## Product Change Notification

### Bourns Trimpot Product Line Announces *Change to Carrier Tape Width & MOQ for Model 70ABJ-4-Male Modular Contact*

#### **Affected Part Number: 70ABJ-4-M0E**

**Figure 1: 70ABJ-4-Male Current Design**

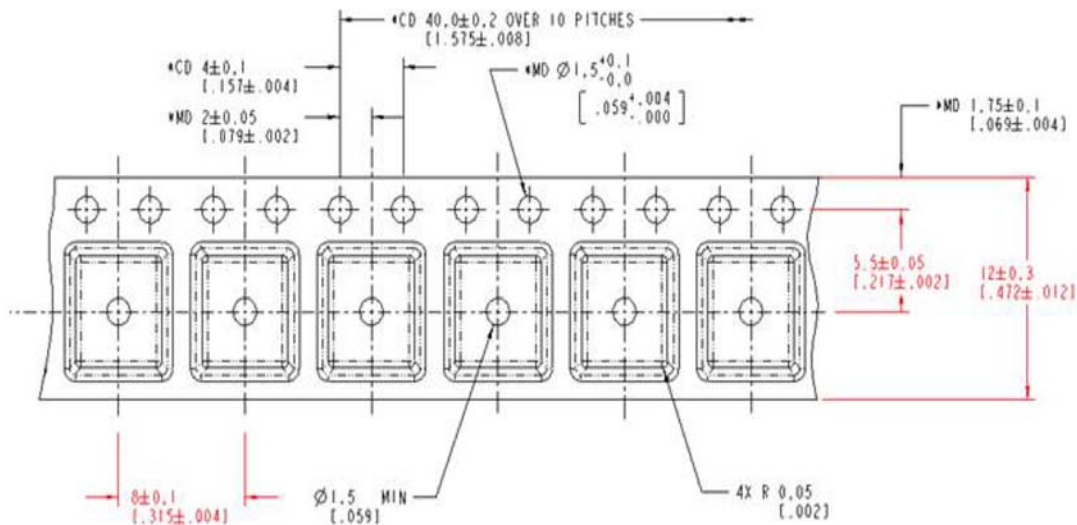
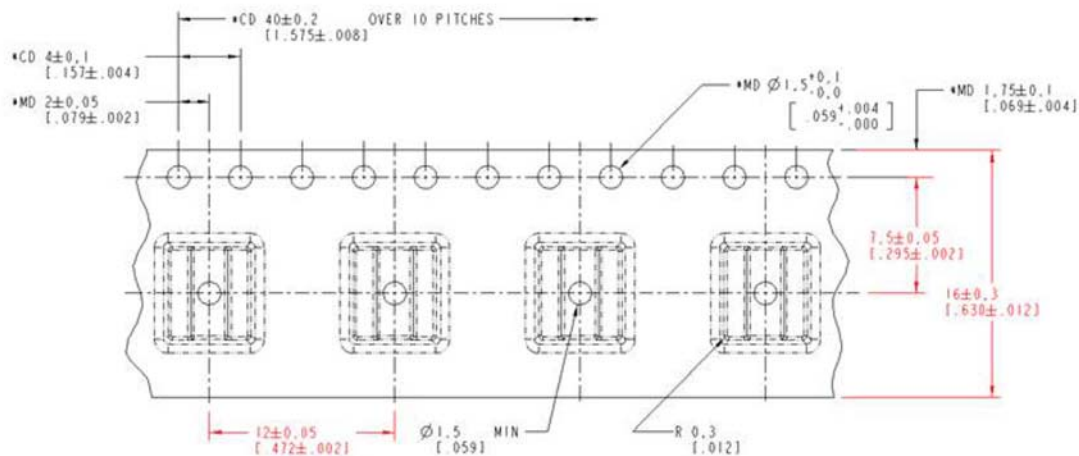
Bourns Trimpot Product Line is changing the carrier tape width for the [Model 70ABJ-4-Male](#) Modular Contact. The carrier width is changing from 12 mm to 16 mm and the carrier tape unit pitch is changing from 8 mm to 12 mm. This improved design helps eliminate the camber effect which can occur after being sealed with cover tape. See Figure 1 and 2 on the next page for the specifications.
